Department of Energy
National Nuclear Security Administration
Washington, DC 20585

**Report on
Annular Core Research Reactor Ventilation System Assessment
at the Sandia National Laboratories (SNL)**

September 2002

Figure 1: HBVES and GIF Ventilation System Nominal Flow Rates

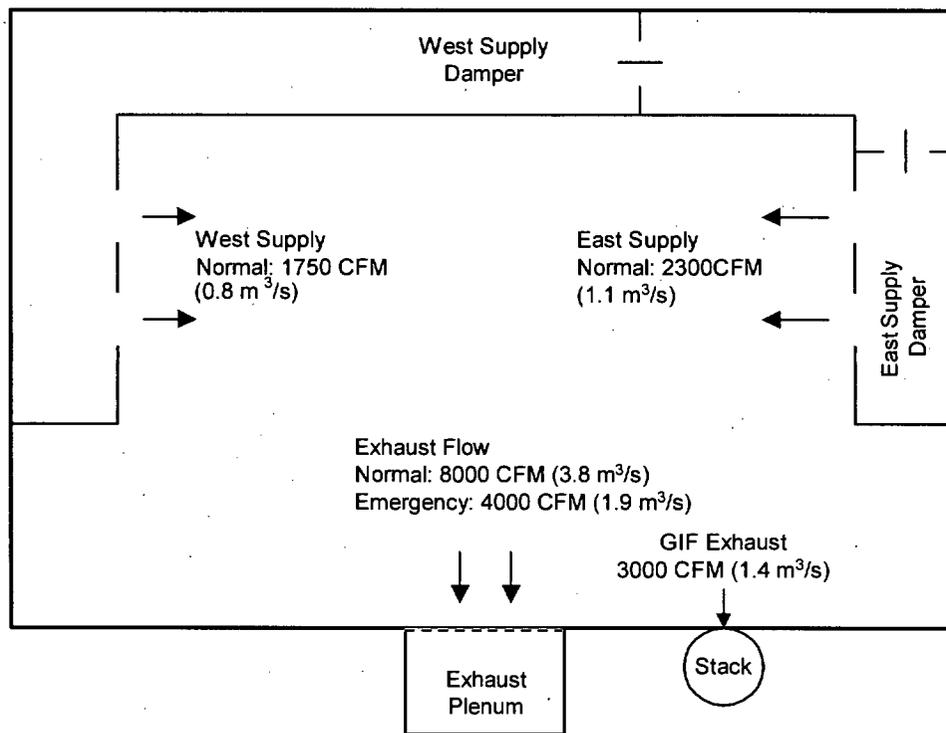
The airflow through the HVBES exceeded the airflow limits by as high as 25%. However, the BOP computer did not show that the airflow exceeded the expected value. The increased airflow challenges the allowable flow rate for the installed HEPA filter. The differential pressure across the HEPA filters was approximately 50% on the BOP of the measured differential pressure. The in-place leak tests for the charcoal adsorber beds in the CPS are not performed and their justification for omission is not documented. Periodic replacement of the adsorbers is being performed.

Verify that the flow rates in the ACRR Surveillance and Test Procedure do not exceed the certified flow limits of the HEPA filters. See paragraphs 3 and 4 under Discussion of Results. [OFI-VSS-ACRR-26]

Figure 2: ACRR Cavity Purge System

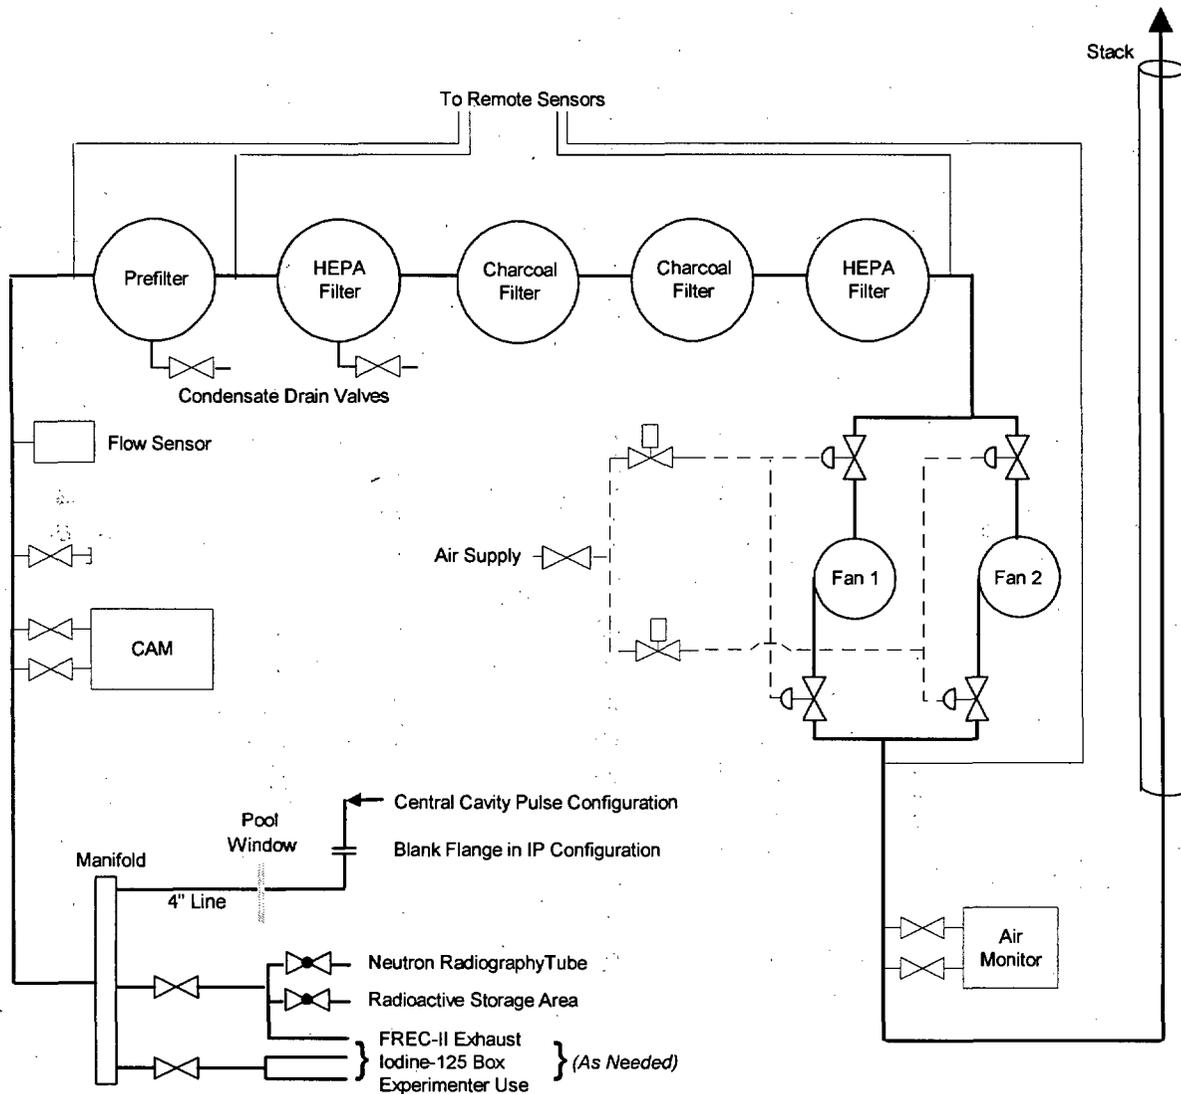
Initial penetration tests showed a penetration of 0.17% on the upstream HEPA filter in the CPS which failed to meet the 0.02% criteria. The fluid seal was repaired and subsequent tests met specifications. The former GIF Ventilation System initial penetration test showed 0.086%. Specifications were met after gasket repair. The initial airflow measurement of the HBVES indicated a flow 5.4% greater than the maximum allowed. Subsequent adjustment of a balancing damper reduced the airflow to within the specifications. The final test results show conformance with the test specifications, however, since the penetration test procedure did not follow the intent of the required test standard, the penetration performance is questionable. The pressure differentials and flows are within specification limits. Adsorber bank in-place leak tests were not performed so performance cannot be verified.
